Bicycle NSW feedback on two intersection upgrades - Bondi LATM

Thank you for the opportunity to comment on the first two Bondi Local Area Traffic Management projects - the Denham Street / Edward Street and Martins Avenue / Ocean Street intersection upgrades.

Both intersections are on important cycling routes through Bondi:

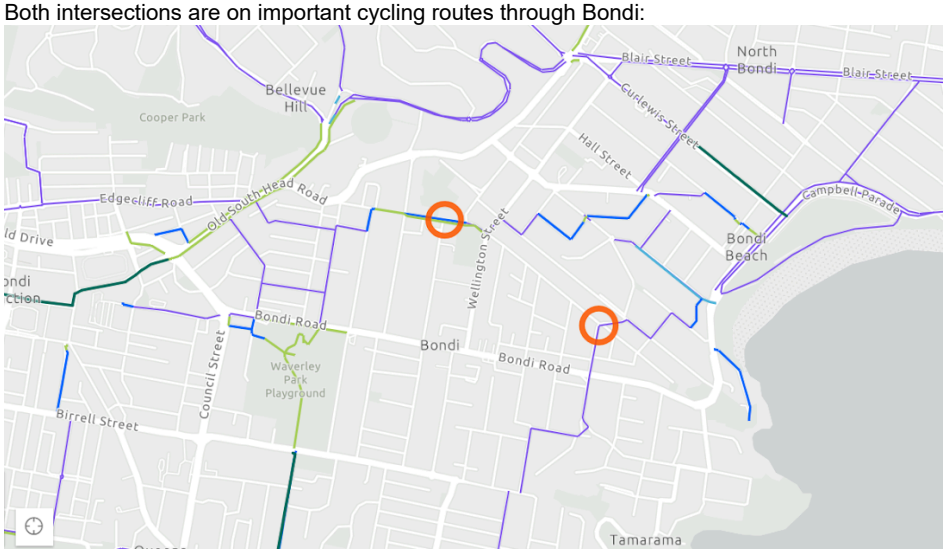
It is therefore critical that the detailed design of the new intersections fully considers the needs of people riding bikes.

The route via Martins Avenue is shown on the Waverley Bicycle Network:

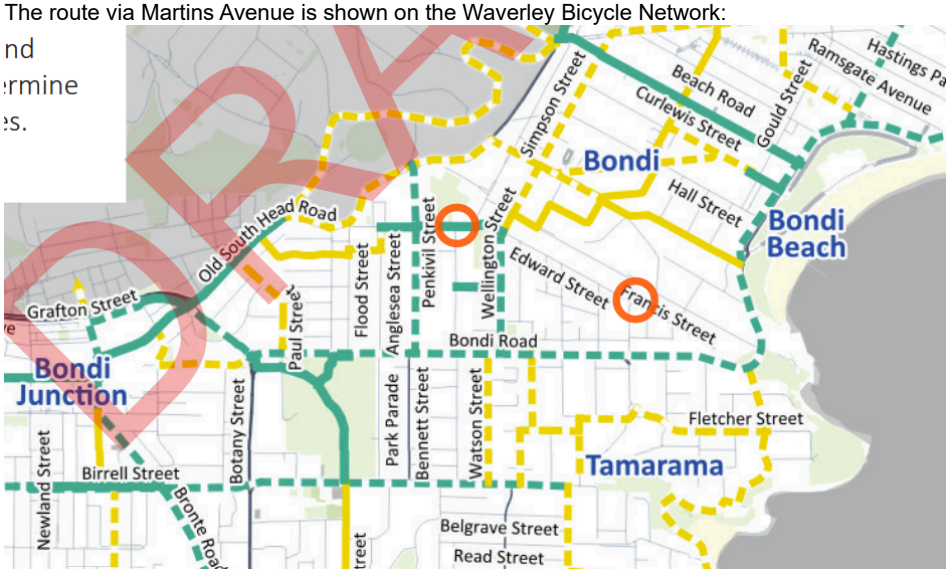
In the longer term, we urge Waverley Council to develop proposals for creating safe space for people of all ages and abilities to cycle in both directions on Martins Avenue. As a key part of the Waverley Bicycle Network, changes to this road will greatly improve access for people riding bikes between the Bondi Basin area and Bondi Junction.
